February 27, 2026

Subject: Addendum 1, **Bid FB-26-07, Asphalt Parking Lot Removal and Replacement, Phase 2, Monte Vista Middle School**

3. Provides Bid Set Drawings Date: 02-25-2026, Pages 1-6 and Specification Section 32-12-16. These supersede original documents.

BID SET DATE: 02-25-2026			
FB-26-07, ASPHALT PARKING LOT REMOVAL AND REPLACEMENT, PHASE 2 MONTE VISTA MIDDLE SCHOOL DEMOLITION PLAN 888 LANTANA ST, CAMARILLO, CA 93010			
SCALE: HORIZ. 1" = 20'		VERT. _____	
WORK ORDER	0835	SHEET NO. 2 OF 6	
DRAWN BY:	VR		
CHECKED BY:	TJS

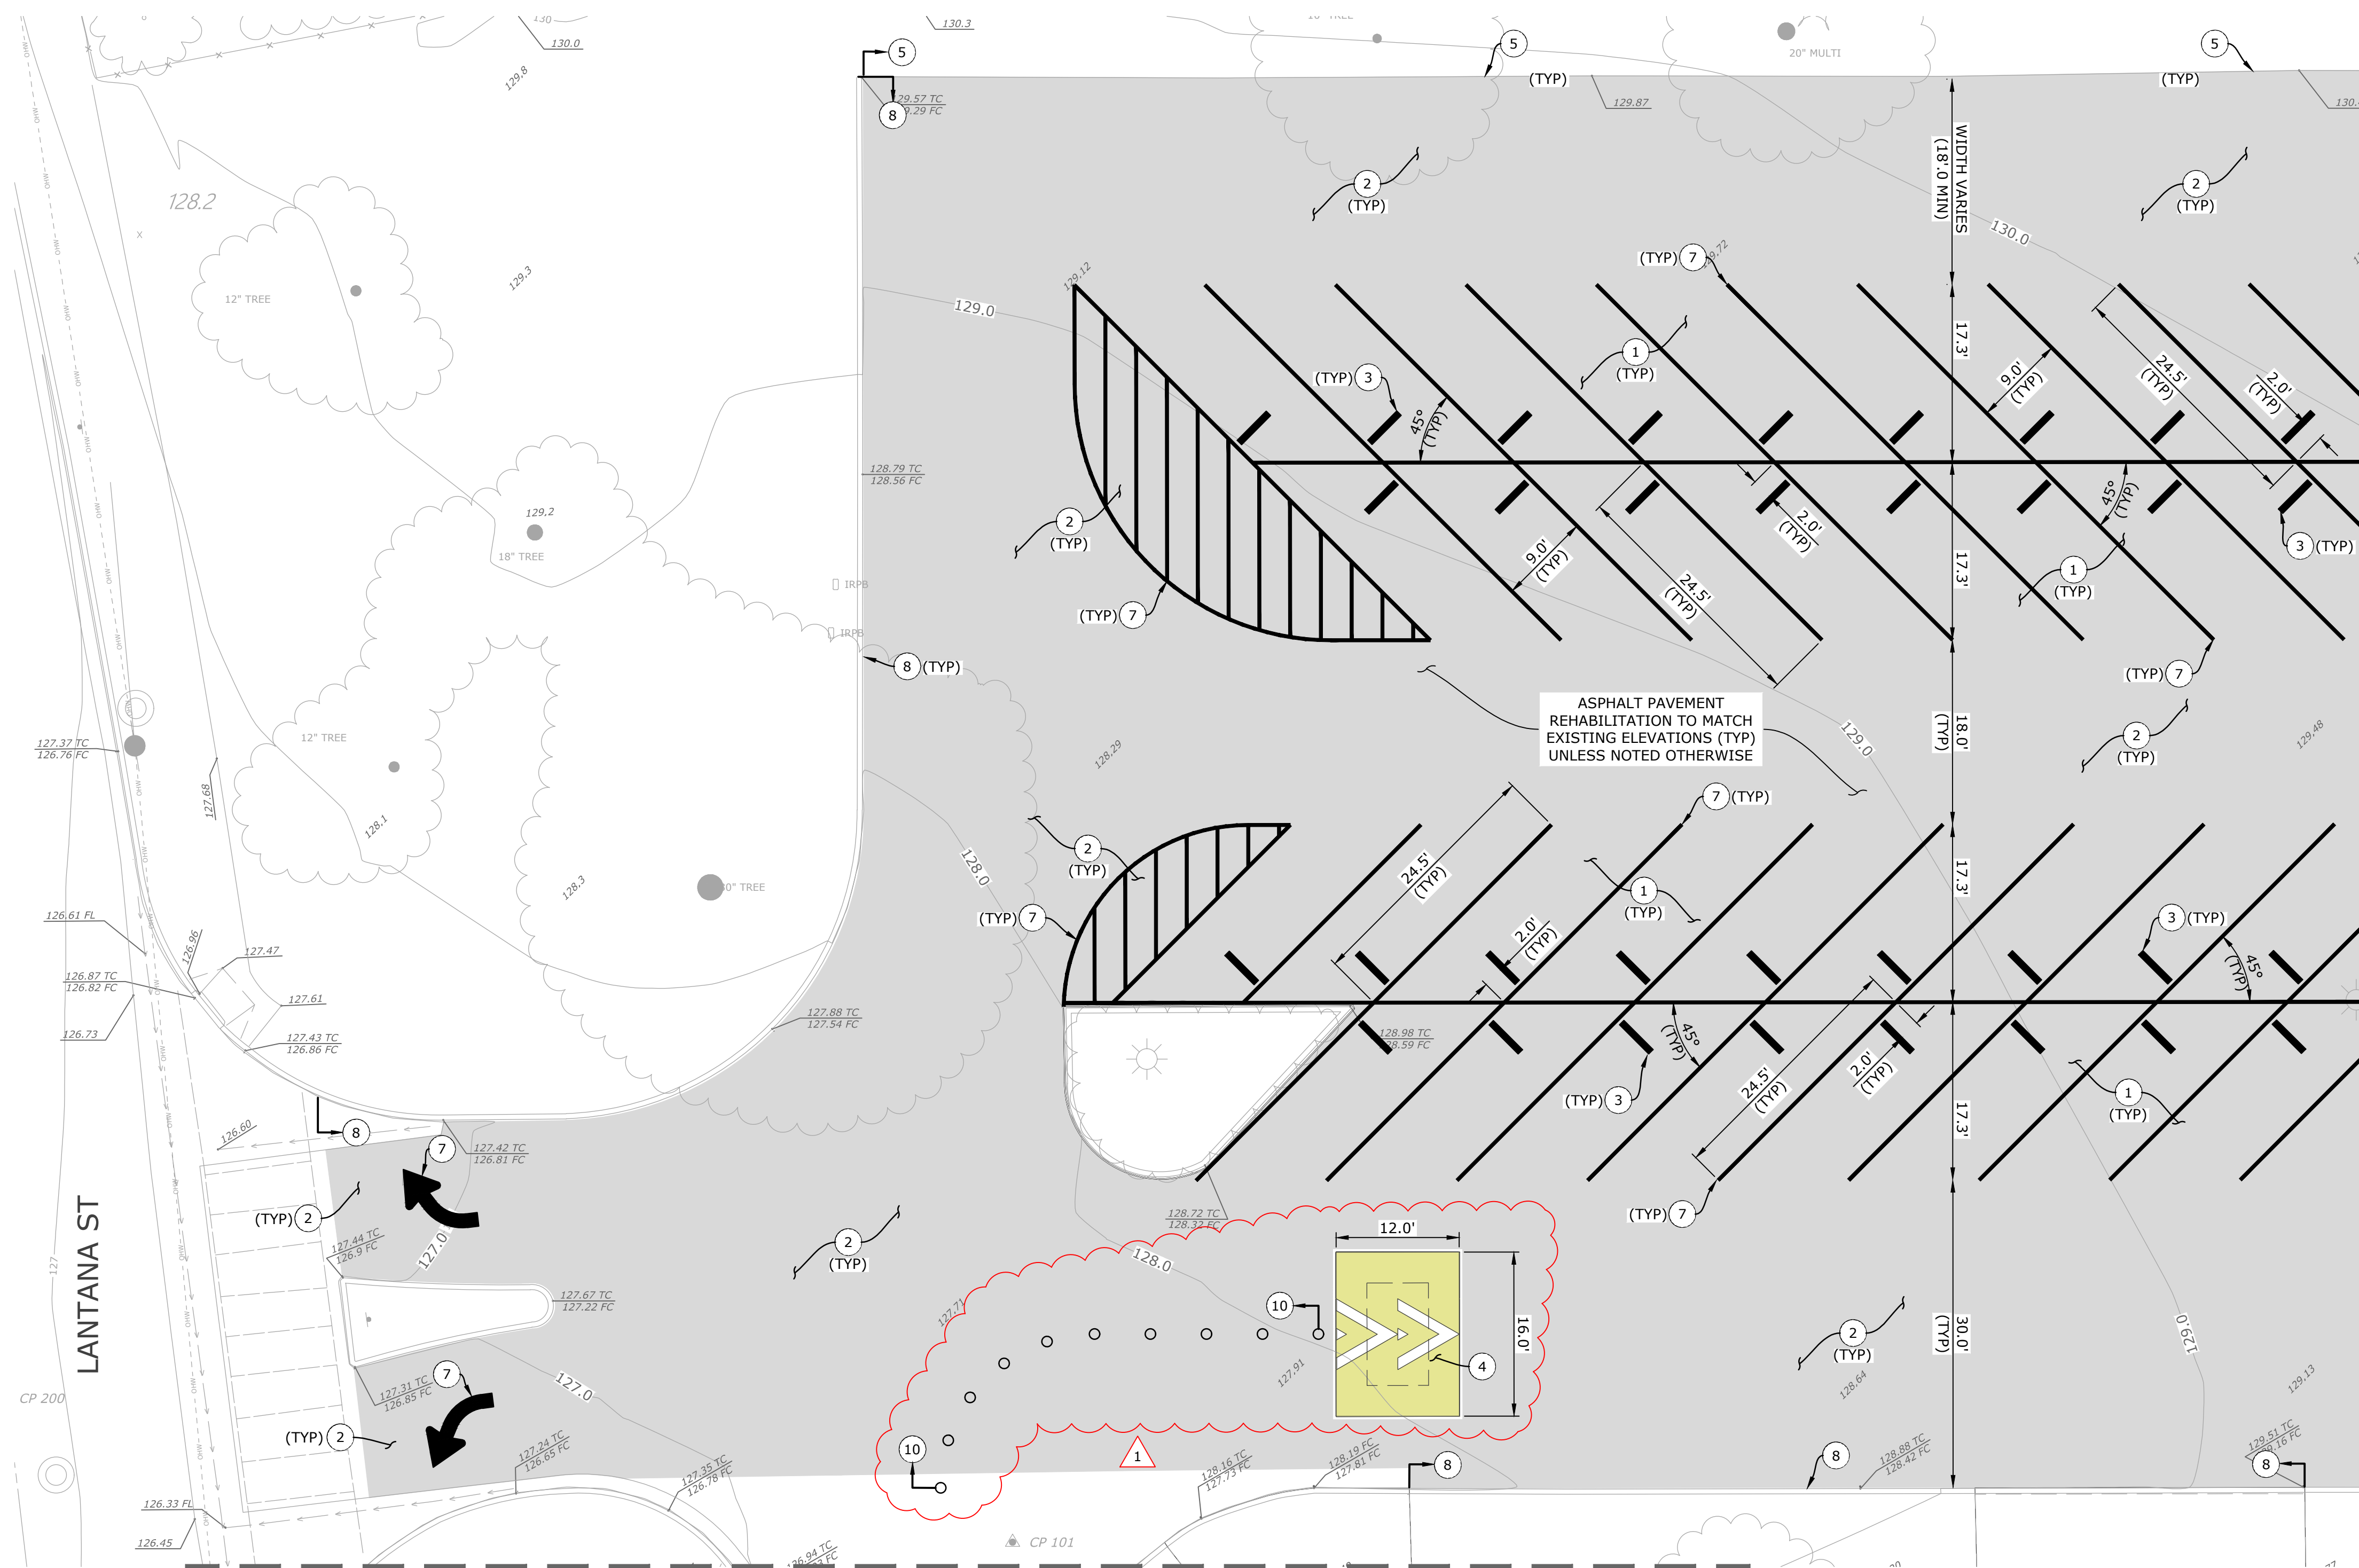
- SAWCUT AND REMOVE EXISTING AC IMPROVEMENTS TO LIMITS SHOWN. REFER TO LEGEND AND PLAN FOR LIMITS OF FULL PAVEMENT SECTION REMOVAL AND AREAS WHERE AGGREGATE BASE TO BE PROTECTED IN PLACE.
- REMOVE AND REPLACE WHEEL STOP. REFER TO GRADING PLANS FOR PROPOSED LOCATIONS.
- EXISTING CURB TO BE PROTECTED IN PLACE.
- EXISTING LIGHT POLES TO BE PROTECTED IN PLACE.
- EXISTING RIBBON GUTTER TO BE PROTECTED IN PLACE.
- EXISTING BOLLARD TO BE REMOVED.
- EXISTING SPEED BUMPS TO BE REMOVED.
- EXISTING SIGN POLE AND BASE TO BE PROTECTED IN PLACE.
- EXISTING INLET TO BE PROTECTED IN PLACE.
- EXISTING SOLAR PANEL ARRAY SHADE STRUCTURE TO BE PROTECTED IN PLACE.
- EXISTING FLEXIBLE LAND DELINEATOR POSTS TO BE REMOVED AND REPLACED IN KIND.

REVISIONS			
MARK	DATE	DESCRIPTION	BY
△	02/25/26	LANE DELINEATOR POSTS, SPEED HUMPS	CPB
REVIEWED BY:			
		DATE	
		DATE

SPEED HUMP DELINEATION

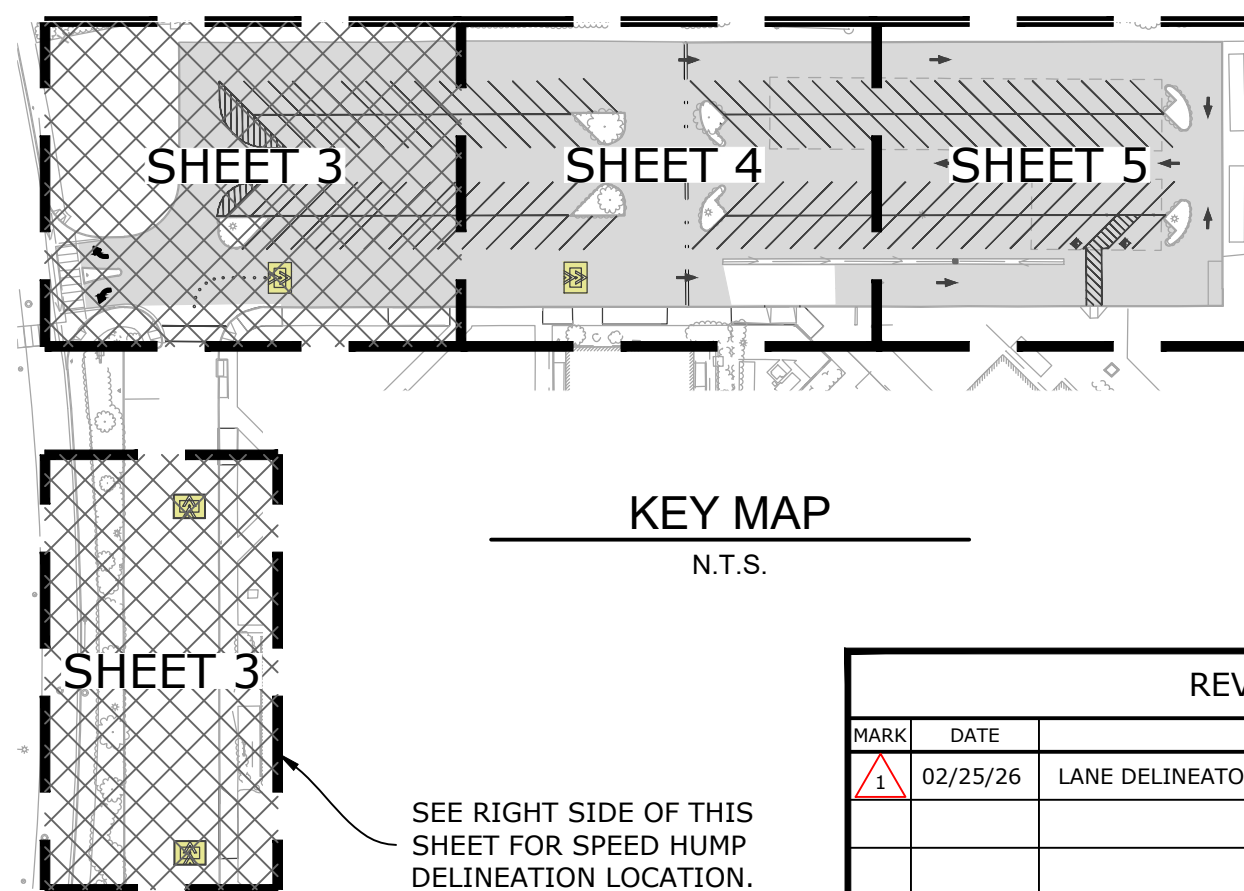
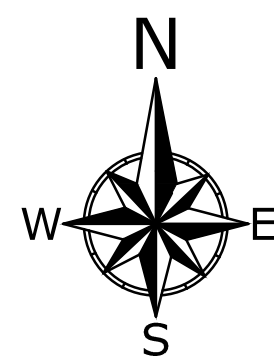
- CONSTRUCT ASPHALT CONCRETE PAVEMENT PER DETAIL "A", SHEET 6.
- CONSTRUCT DRIVE AISLE ASPHALT CONCRETE PAVEMENT PER DETAIL "B", SHEET 6.
- CONSTRUCT WHEEL STOP PER DETAIL "C", SHEET 6.
- CONSTRUCT SPEED HUMP PER DETAIL "D", SHEET 6. FURNISH AND INSTALL 4" WIDE STRIPING AROUND BASE OF SPEED HUMP TO MATCH PARKING STALL STRIPING.
- CONSTRUCT REDWOOD HEADER ADJACENT TO LANDSCAPING PER DETAIL "E", SHEET 6.
- PARKING LOT STRIPING SHALL BE 4" WIDE WHITE NON-REFLECTORIZED PAINT. PAVEMENT MARKINGS SHALL BE SAME SIZE AND MATERIAL AS EXISTING CONDITION.
- CONSTRUCT RED CURB TO LIMITS SHOWN. MATCH EXISTING CURB COLOR.
- REPAIR AND REPAINT EXISTING SPEED HUMP WITH TRAFFIC YELLOW PAINT CONFORMING TO FEDERAL STANDARD 595B COLOR NUMBER 33538 AND TAPERED EDGES PER DETAIL "D", SHEET 6.
- REPLACE FLEXIBLE LANE DELINEATOR POSTS IN KIND.

SEE RIGHT SIDE OF THIS SHEET FOR SPEED HUMP DELINEATION LOCATION.

REVISIONS			
MARK	DATE	DESCRIPTION	BY
1	02/25/26	LANE DELINEATOR POSTS, SPEED HUMPS	CPB
REVIEWED BY:			
DATE		DATE	
DATE		DATE

SPEED HUMP DETAIL

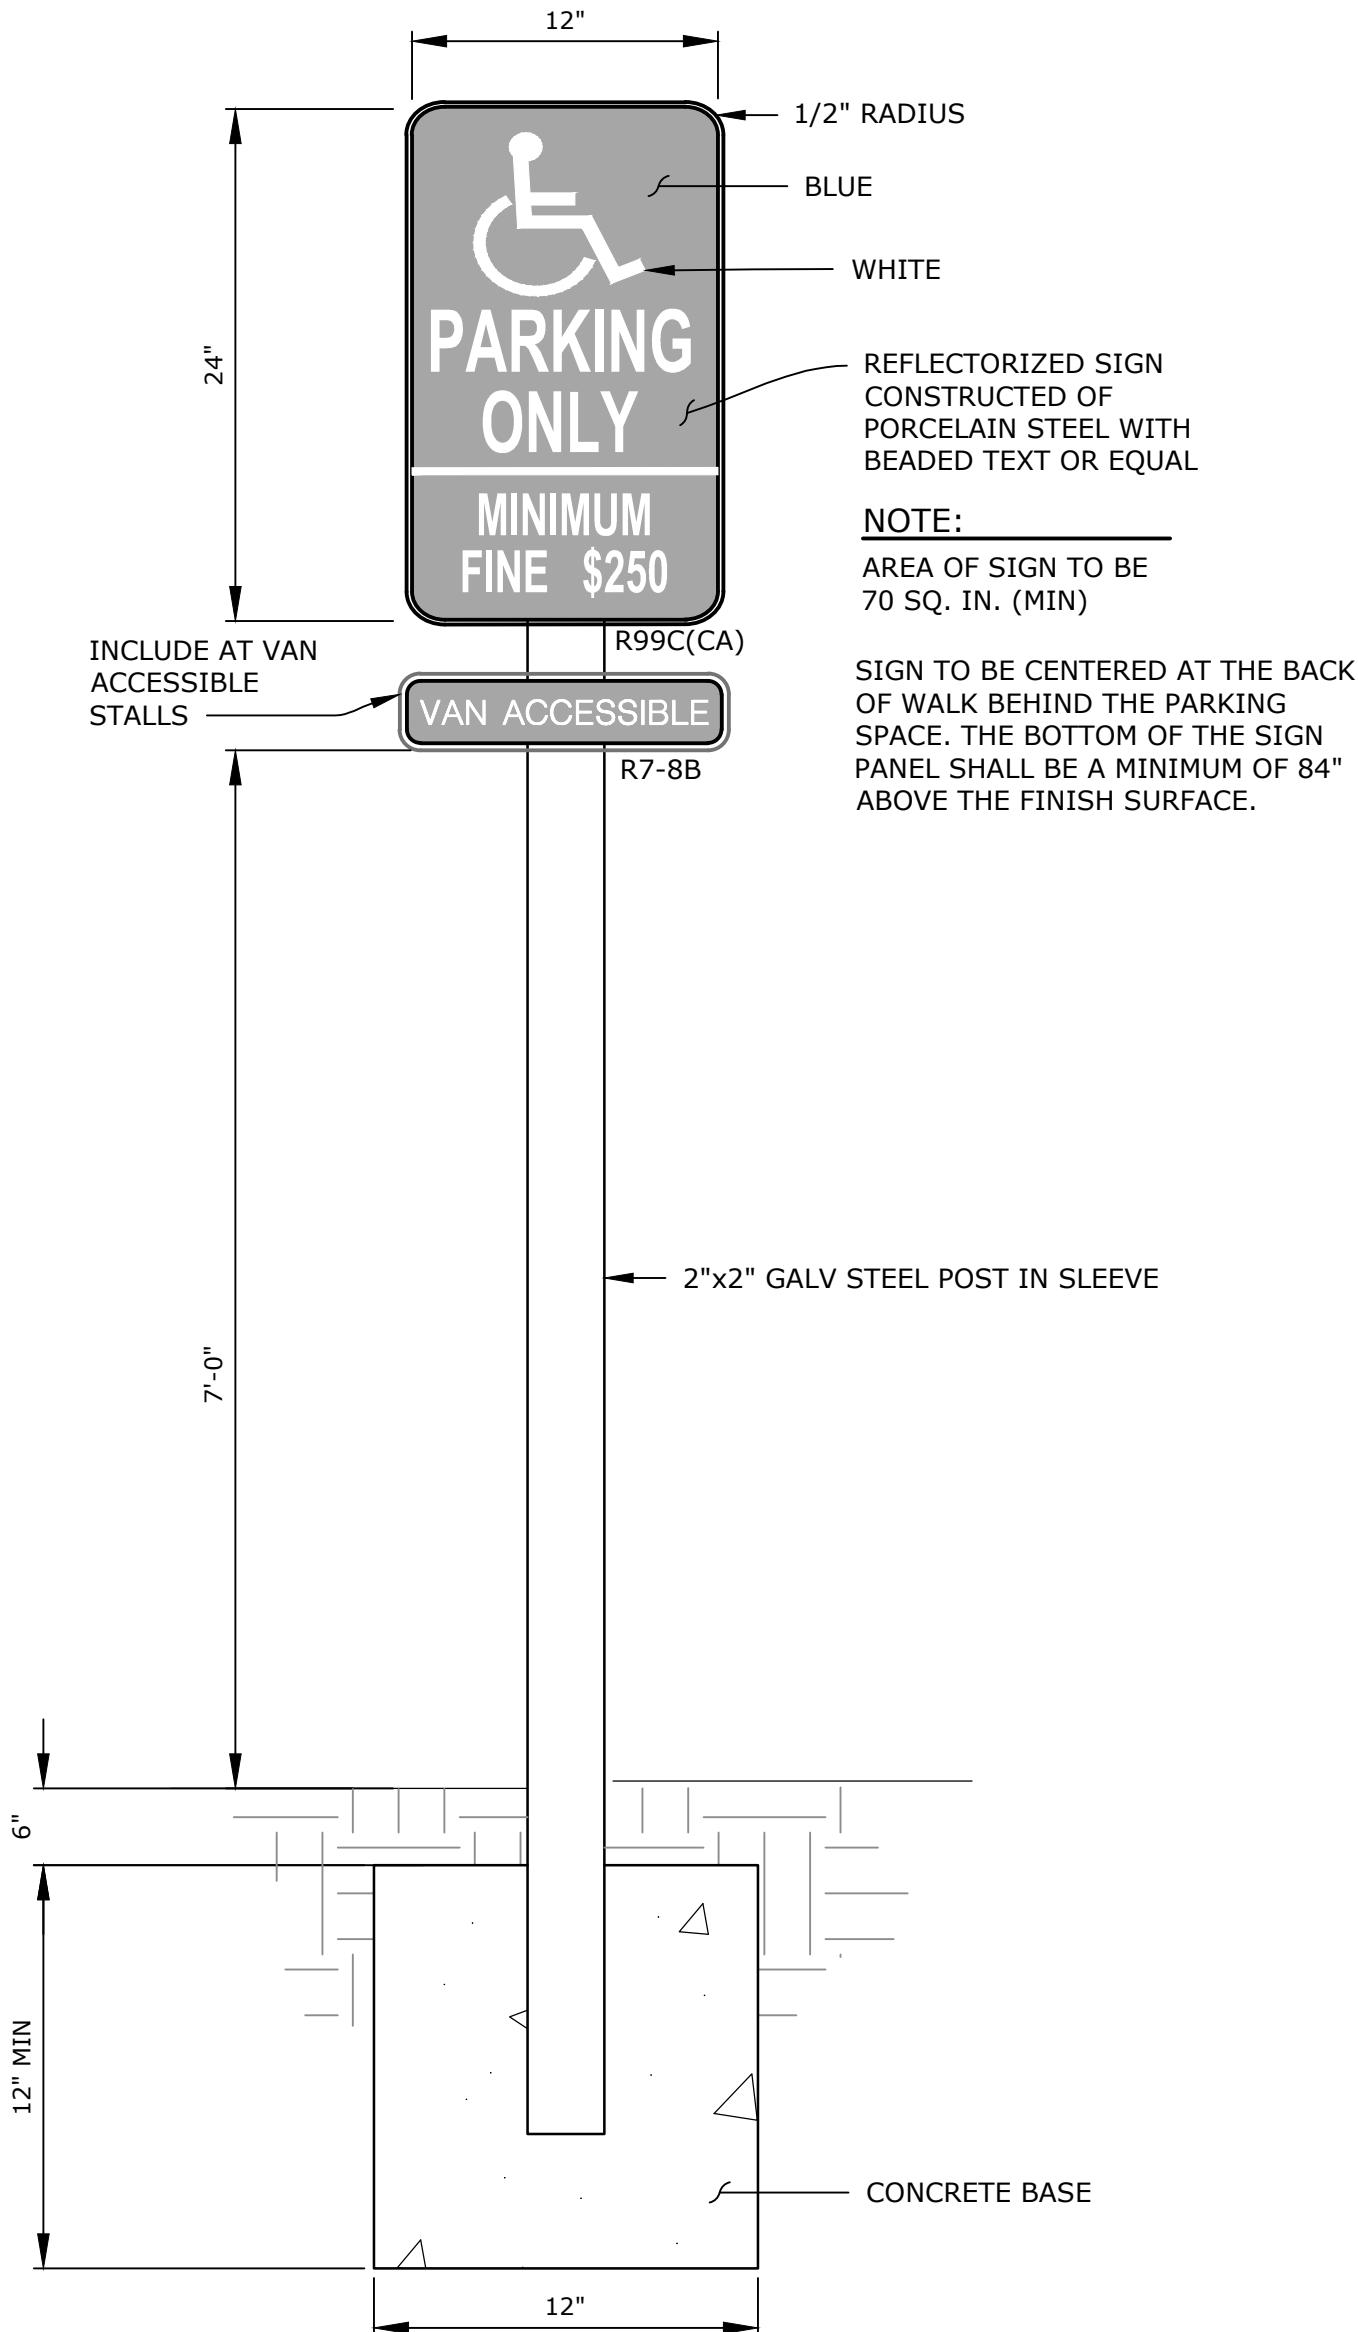
1. INSTALLATION SHALL CONFORM TO THE LATEST CITY OF CAMARILLO STANDARD PLANS AND CALIFORNIA MANUAL ON UNIFORM TRAFFIC CONTROL DEVICES STANDARDS.
2. SPEED HUMPS SHALL NOT BE PLACED OVER MANHOLES, MAINTENANCE COVERS, ETC.
3. EDGE OF SPEED HUMP SHOULD BE 5' OR MORE FROM EDGE OF DRIVEWAY OR CATCH BASIN.
4. ASPHALT JOINS SHALL BE ACCOMPLISHED BY GRINDING AND FILLING A 1"x24" CUT.
5. ACCEPTABLE TOLERANCE FOR 3" HEIGHT OF THE SPEED HUMP IS $\pm \frac{1}{8}$ ".
6. FURNISH AND INSTALL TRAFFIC YELLOW PAINT, CONFORMING TO FEDERAL STANDARD 595B COLOR NUMBER 33538, ONTO THE ENTIRETY OF THE SPEED HUMP. ALLOW PAINT TO DRY BEFORE INSTALLING REFLECTIVE WHITE PAVEMENT MARKINGS.
7. FURNISH AND INSTALL 4" STRIPE AROUND BASE OF SPEED HUMP TO MATCH EXISTING PARKING STALL STRIPING.
